Urgent Field Safety Notice Product Correction

Product Name	List Number	Serial Number	UDI
Alinity c Cuvette Segment	04S47-01	All	Not applicable

Appendix A: Updated Alinity ci-series Operations Manual and Procedures

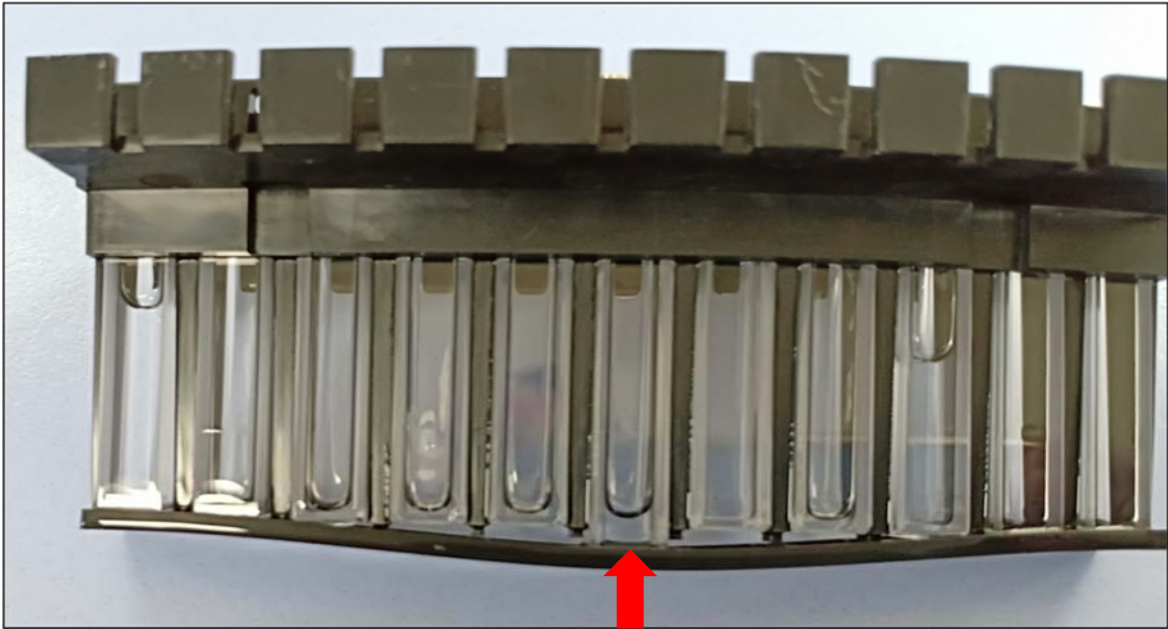
The following pictures show examples of Alinity c cuvette segments where cuvettes are seated lower than designed height:

The red arrow indicates where a cuvette is seated lower than it's designed height

To inspect the cuvette segment, gently pull the segment base downward at several locations along the segment. Replace the cuvette segment if any of the following issues are identified:

- The cuvette segment base is detached.
- One or more cuvettes are seated lower than the other cuvettes in the segment.
- One or more cuvettes are damaged.
